Vermont Agency of Transportation
RECEIVED
 CK'D BY JG, RF OK'D BY GL
 February 2, 2016
 RESUBMIT YES Rejected
 BY KH DATE 2-23-2016

GUARD RAIL TO BRIDGE RAIL TRANSITION

SPECIAL PROVISION, GRAS - CONCRETE COMBINATION BR.
 ROUTE NO. T.H. 3 (CLASS 2), RURAL COLLECTOR, BRIDGE # 11
 TOWN OF CLARENDON, RUTLAND COUNTY, VT.

ITEM #: 900.620 SHEET 1 OF 9

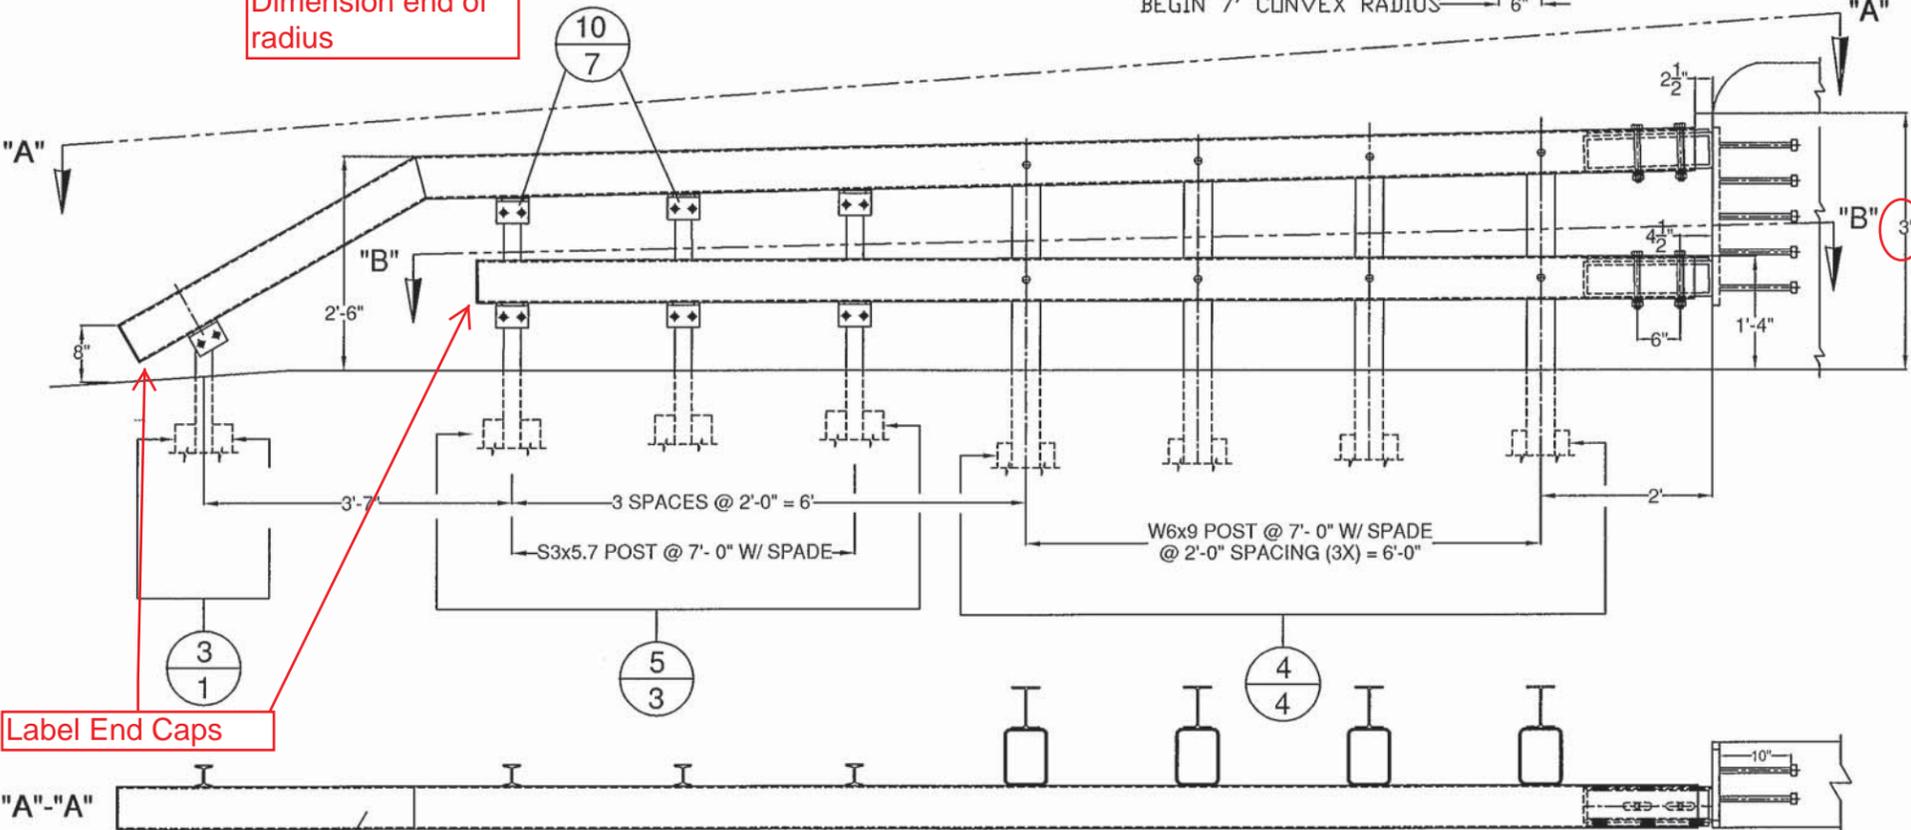
Please Provide weld Procedure for Pie Cut and Chord

Please provide weld procedure for kick down?

End Caps are only labeled for the Lower Rail on WW2 and WW3. An End Cap should be shown on every kick back and kick down where the rail terminates.

Wing Wall 1 Approach Rail will need to be bent in the vertical direction as well. Theoretical Ground Elevations are given at each post location on sheet 20 of the Contract Plans.

Dimension to Top of Plate is 2'-10" (TYP)

Dimension end of radius

Label End Caps

Clarify Pay Item as there are two different 900.620 Items for Guardrail. Label as Item 900.620 Special Provision (Guardrail Approach Section to Concrete Bridge Railing). These approach rail drawings will not be considered as a submittal for Item 900.620 Special Provision (Guardrail End Assembly, Type IIA).

SHEET 2 OF 9

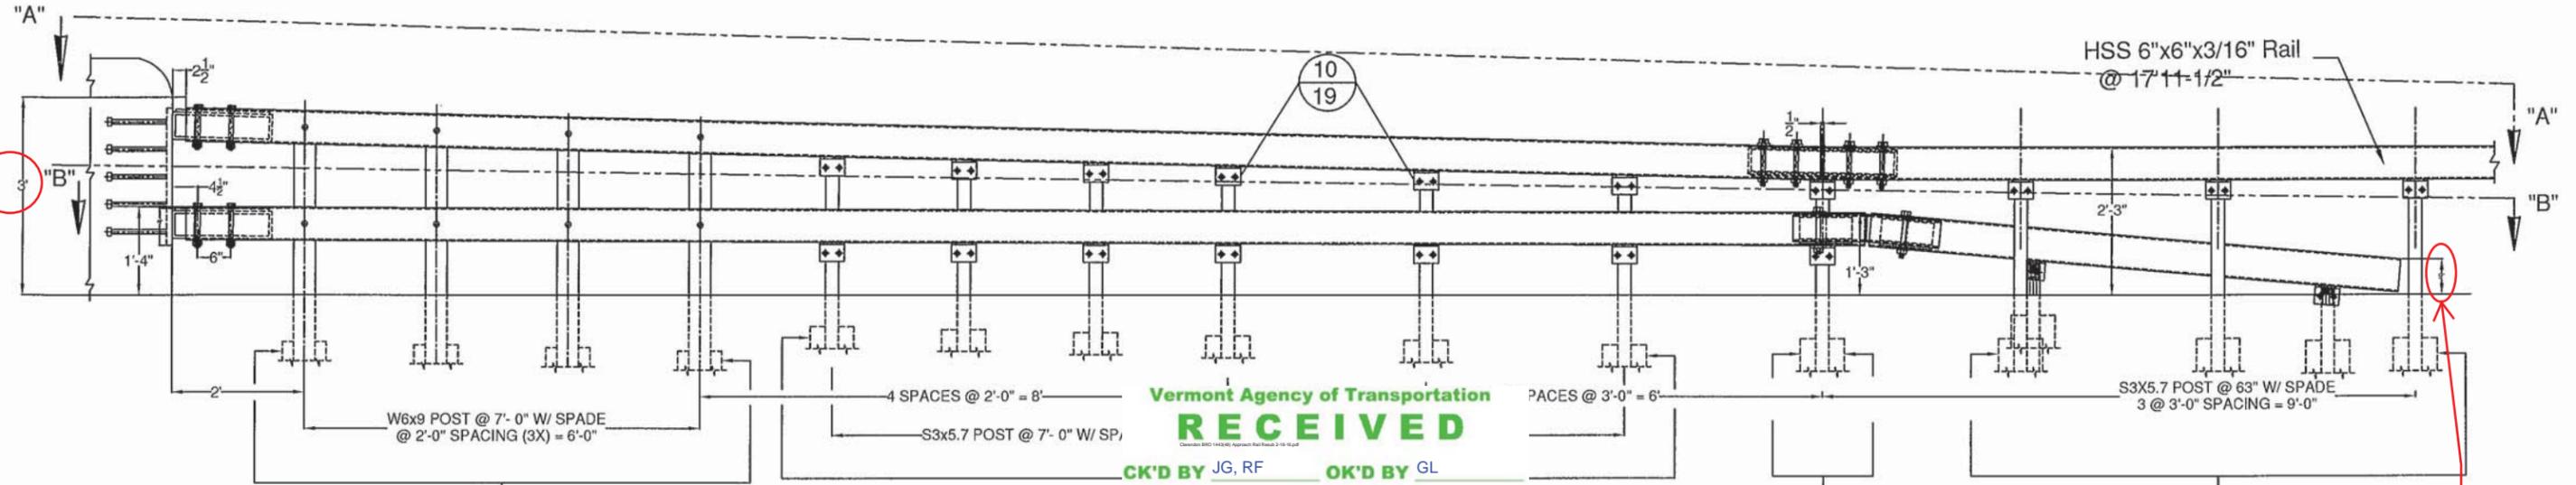
Label as Item 900.620 Special Provision (Guardrail Approach Section to Concrete Bridge Railing).

WW3

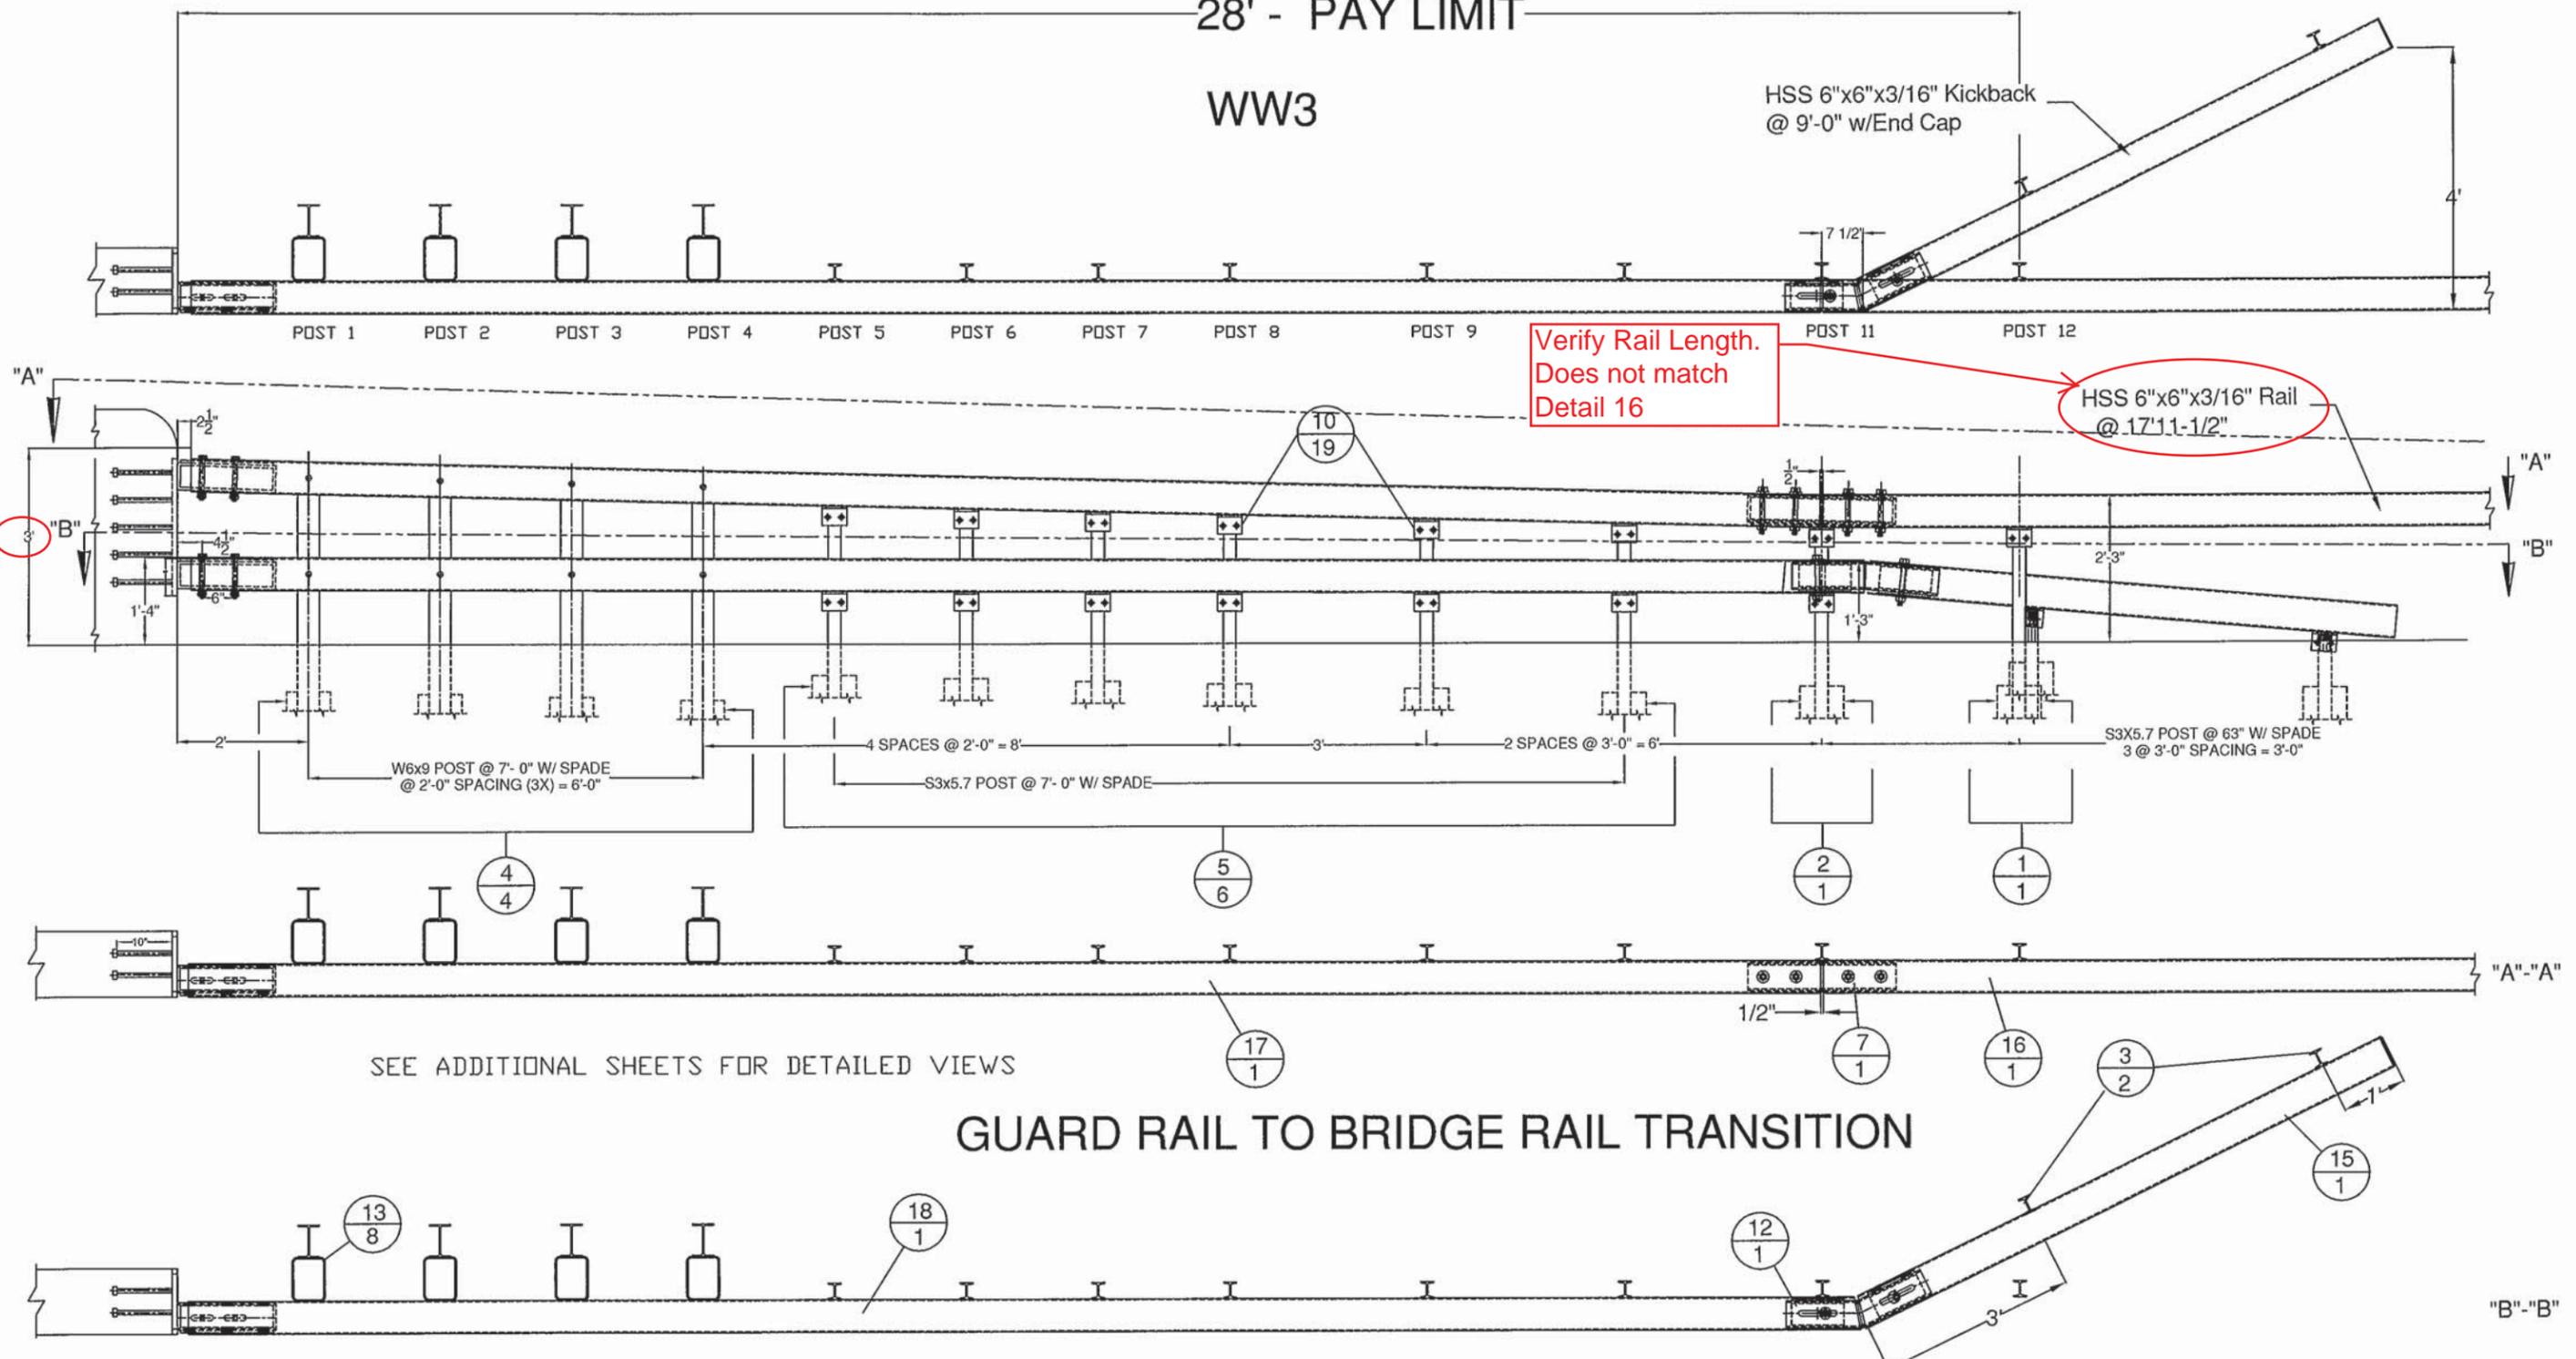
Label as Item 900.620 Special Provision (Guardrail Approach Section to Concrete Bridge Railing).

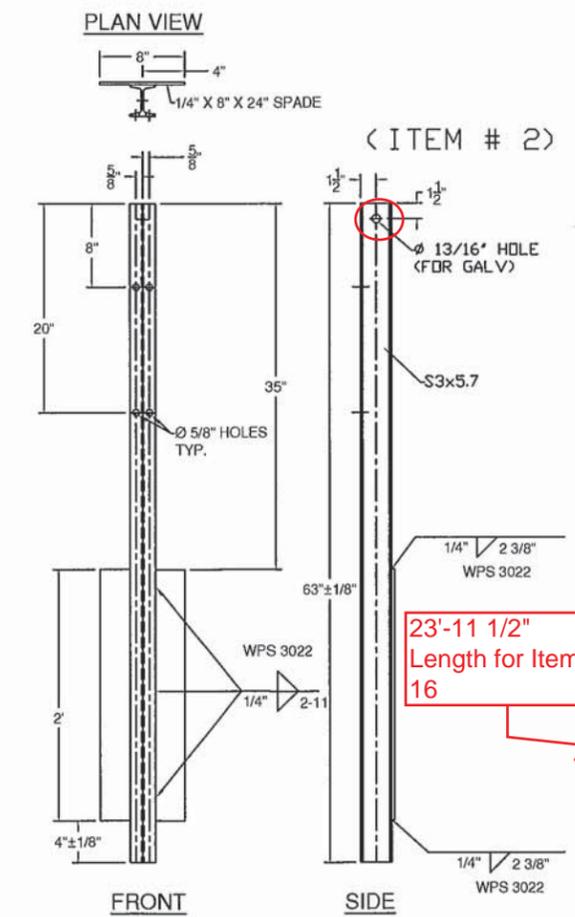
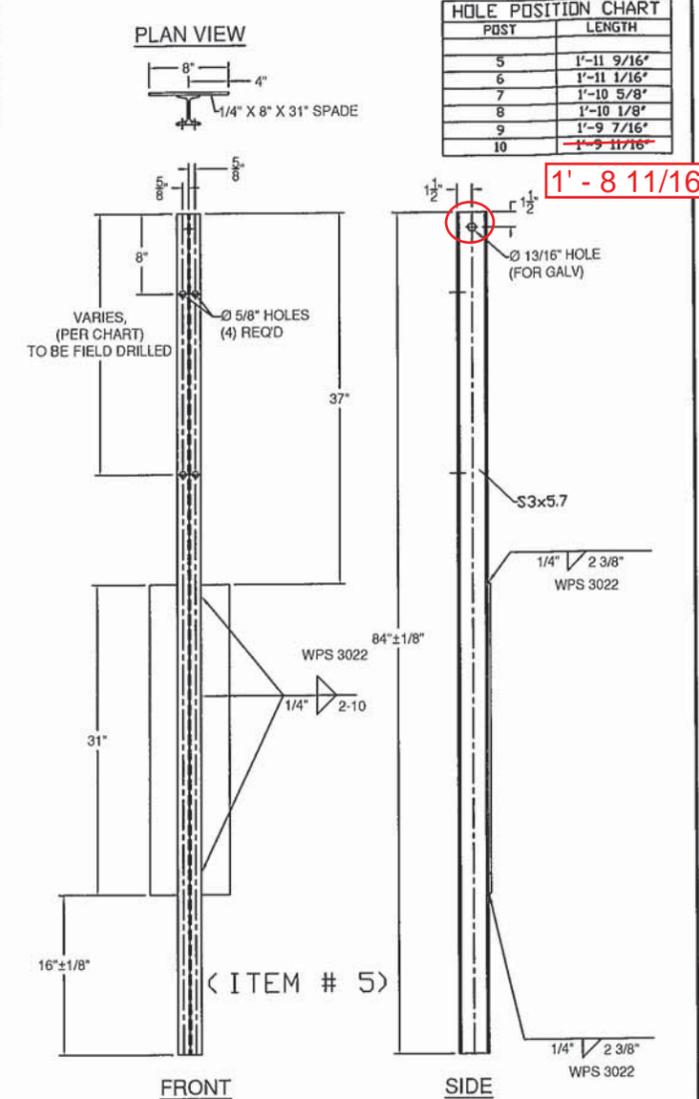
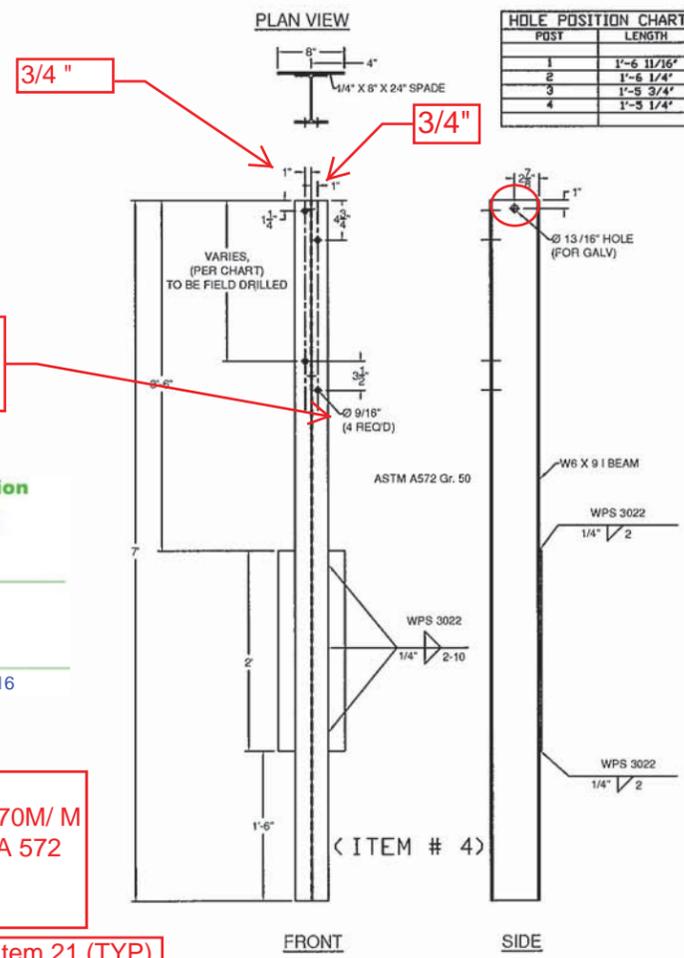
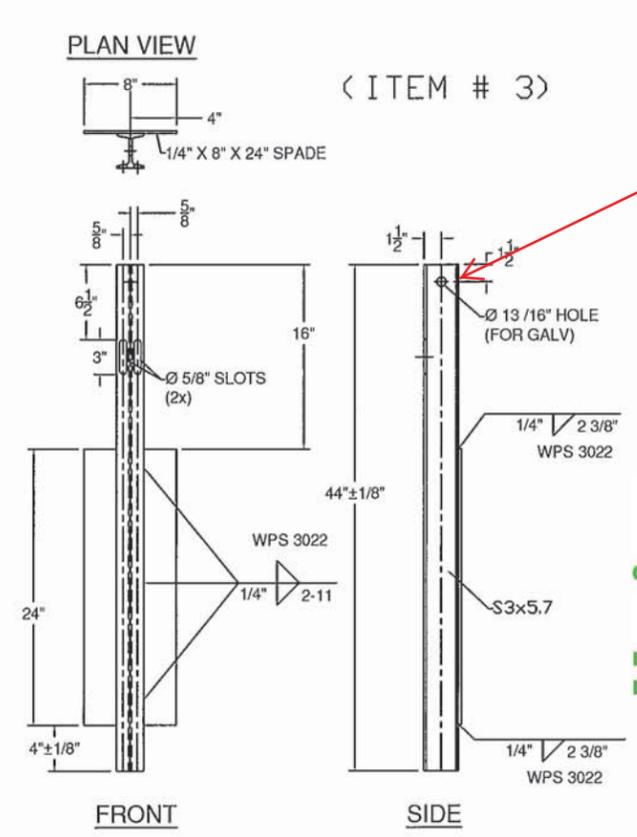
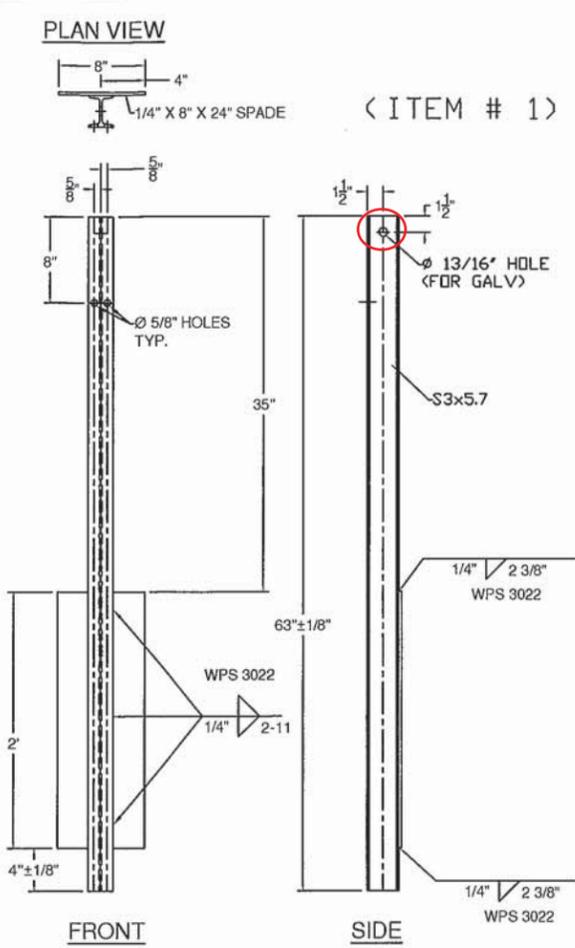
Hole shall be at bottom of the post. See Box Beam Details Sheet.

5/8" Diameter hole Typically used for 1/2" Delta

Item 10 shall conform to the requirements of AASHTO M 270M/ M 270 Grade 345 (50) or ASTM A 572 per subsection 732.03 of the standard specifications (TYP)

Lock Washer not required for Item 21 (TYP)

23'-11 1/2" Length for Item 16

ITEM #: 900.620 Label as Item 900.620 Special Provision (Guardrail Approach Section to Concrete Bridge Railing).

6" X 6" X 3/16" WELDED END CAP, W/CUT CORNERS

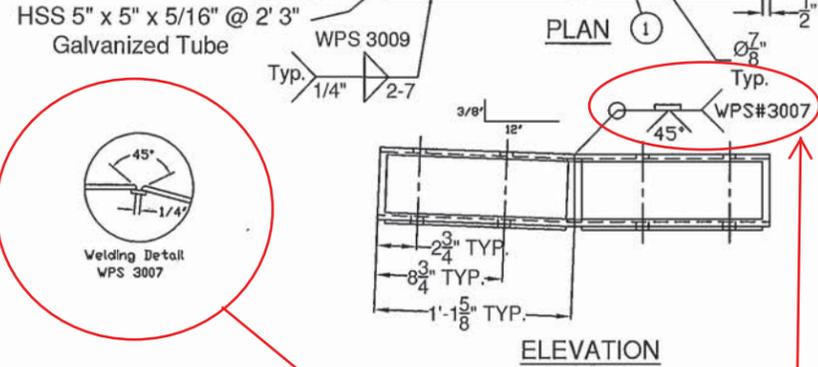
Provide Weld Details for End Cap.

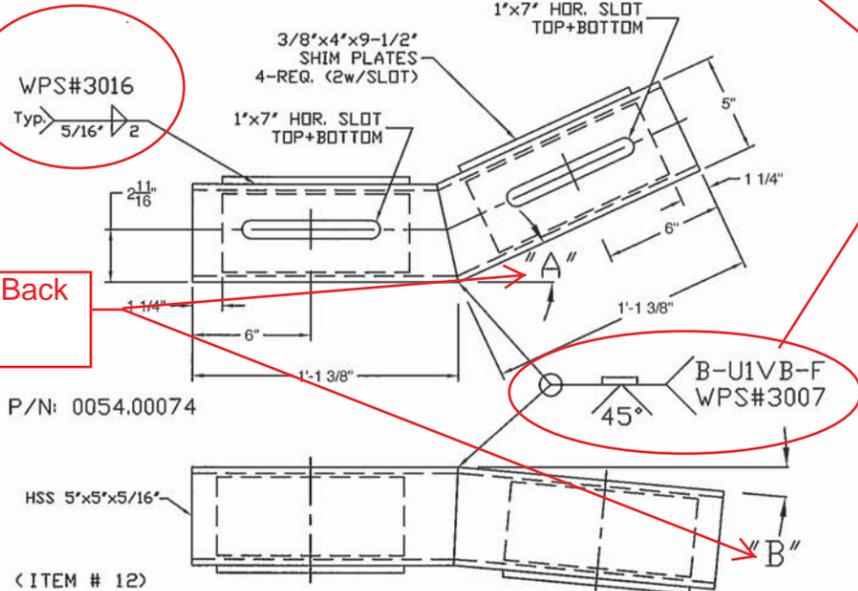
Weld is intended to be a 2x2" intermittent weld.

(ITEM # 10)

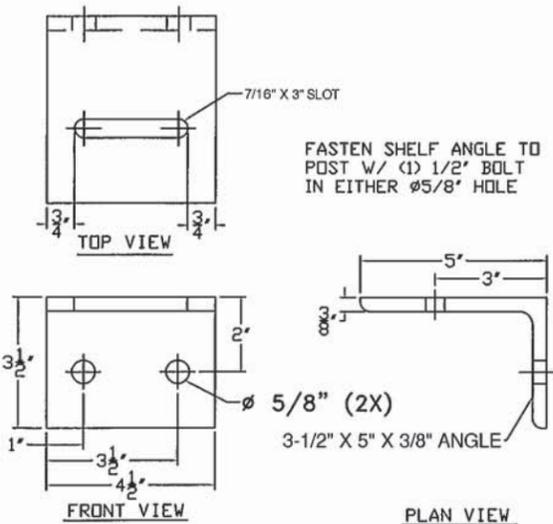
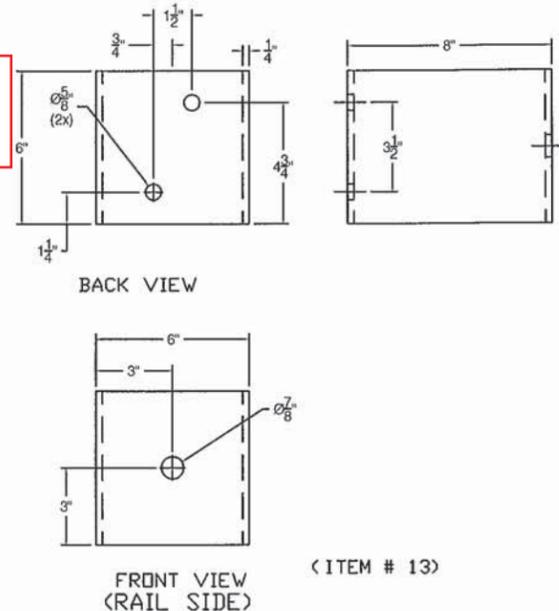
Please detail Turn Back Angle Values

This detail doesn't match what is shown on WPS #3007
